CITY OF WESTMINSTER			
PLANNING APPLICATIONS COMMITTEE	Date 9 February 2016	Classification For General Release	
Report of Director of Planning		Ward(s) involved Lancaster Gate	
Subject of Report	14 Garway Road, London, W2 4NH,		
Proposal	Excavation of a new basement floor beneath the existing lower ground floor and front garden with rooflights and clerestory windows to front lightwell and internal works including installation of three internal rooflights between basement and lower ground floor levels. Removal of tree from front garden.		
Agent	Manalo & White Architects		
On behalf of	Mr Helio Romero de Diego		
Registered Number	15/05881/FULL & 15/05882/LBC	Date amended/ completed	17 July 2015
Date Application Received	30 June 2015		
Historic Building Grade	II		
Conservation Area	Bayswater

PLANNING PERMISSION DRAFT DECISION LETTER

LISTED BUILDING CONSENT DRAFT DECISION LETTER

Proposed Lower Ground Floor

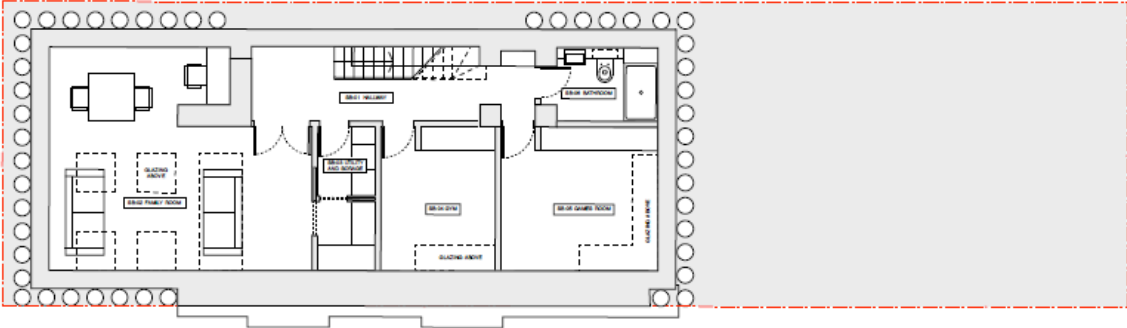
In terms of the impact of the proposed basement on the interior of the listed building, the large glazed panels proposed in the lower ground floor level floor structure to provide borrowed light to the basement below are of significant concern. A glazed floor panel 2.6 metres wide in front of the front basement window and a 2.3 metre wide glazed panel in front of the chimney breast, with its historic cast iron range, in the rear room would be atypical insertions of an overtly modern character, into what should be a lower key subsidiary area of the building. The panels would contrast with original architectural features of the front window and the cast iron range and indicate in a permanent manner that the hierarchy of the building had been disrupted with an additional basement floor.

Because of the location and extent of the glazed panels set into the floor of the front and rear rooms of the original building at lower ground floor level, the basement excavation would harm the internal character and integrity of this grade II listed building. This would be against the advice set out in S25 and S28 of Westminster's City Plan: Strategic Policies adopted November 2013, DES 1 of our Unitary Development Plan that we adopted in January 2007 and the advice set out policy HB 1, (paragraph 2.4) of our 'Supplementary Planning Guidance: Repairs and Alterations to Listed Buildings' (1996). (X18AB)

Required amendments: Retain Mulberry tree, reduce the basement extent so as to not to extend beneath front garden, omit clerestory window and revise design of front light well, introducing a grille rather than glazing. It is recommended that consideration is given to creating a positive symmetry with No.12.

Proposed Basement Floor

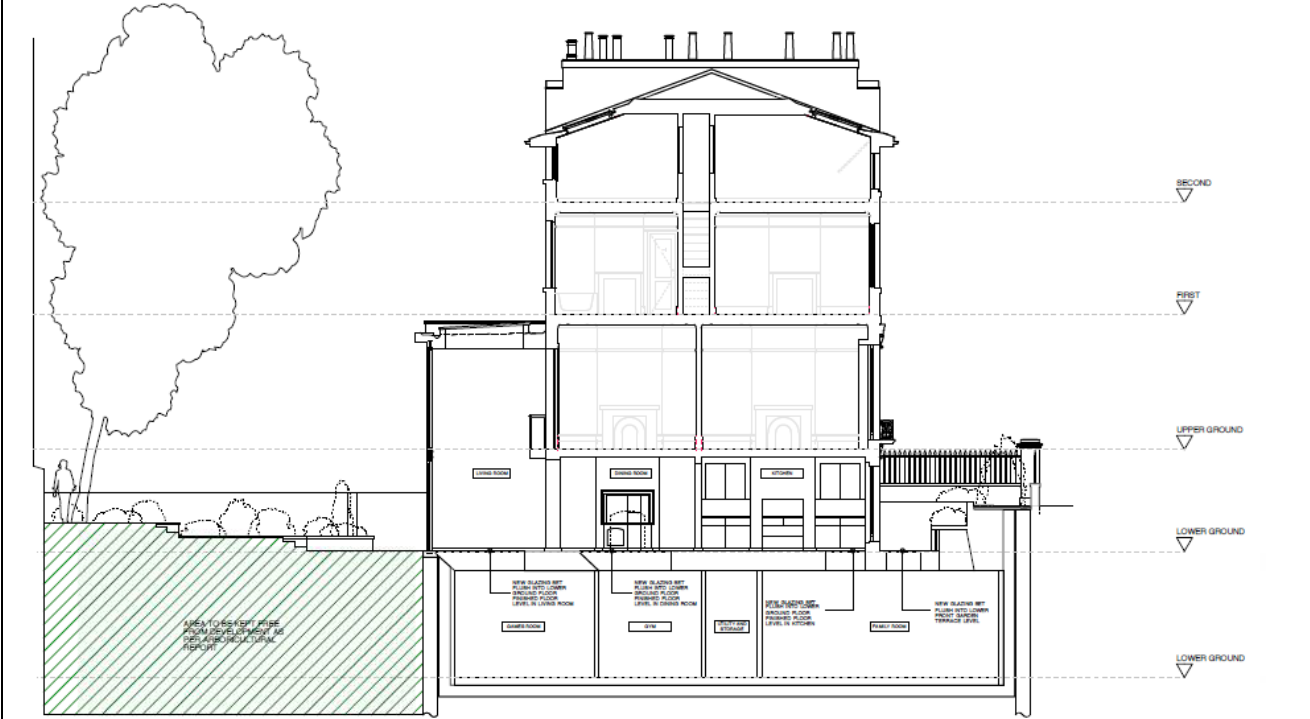
Externally the manifestation of the basement floor would be limited to alterations to the existing lower ground floor front lightwell, with the introduction of two rooflights and clerestory windows. Both of these alterations in a prominent position to the front of a listed building are of concerns in design terms. The rooflights, although limited in size and set within paving, would appear as alien modern additions to the building. Similarly the clerestory windows to the lightwell would be atypical architectural feature for a building of this period and would be visible when looking out of the front basement window and from the overlooking and adjoining properties. Both the lightwells and the rooflights would contribute to a wash of light to the base of the front elevation thereby 'giving away' the presence of the proposed basement floor level, which has little

reference to the originally intended hierarchy of these relatively modest villa buildings. Therefore, whilst it is considered that there is scope for alteration to the front lightwell to provide light to basement level; it should be achieved in a more traditional manner than is currently proposed.

The Arboricultural Manager objects to the loss of the Mulberry tree in the front garden and the lack of replacement soil depth within the garden area that would be of sufficient depth to support future mature planting along the front boundary of the site. The Mulberry tree is considered to be an attractive tree that makes a positive contribution to the character and

appearance of the Bayswater Conservation Area. The loss of the tree and the inability for it to be adequately replaced within the front garden (even if its loss was accepted) as part of a replacement landscaping scheme would be contrary to Policies ENV16, ENV17 and DES9 in the UDP and Policy S25 in the City Plan. It would also be contrary to the guidance within the 'Basement Development in Westminster' Supplementary Planning Document (2014), which sets out that existing trees of visual amenity value and requires 1.2 metre of soil depth (including drainage layer) over the basement structure where it extends below garden areas.
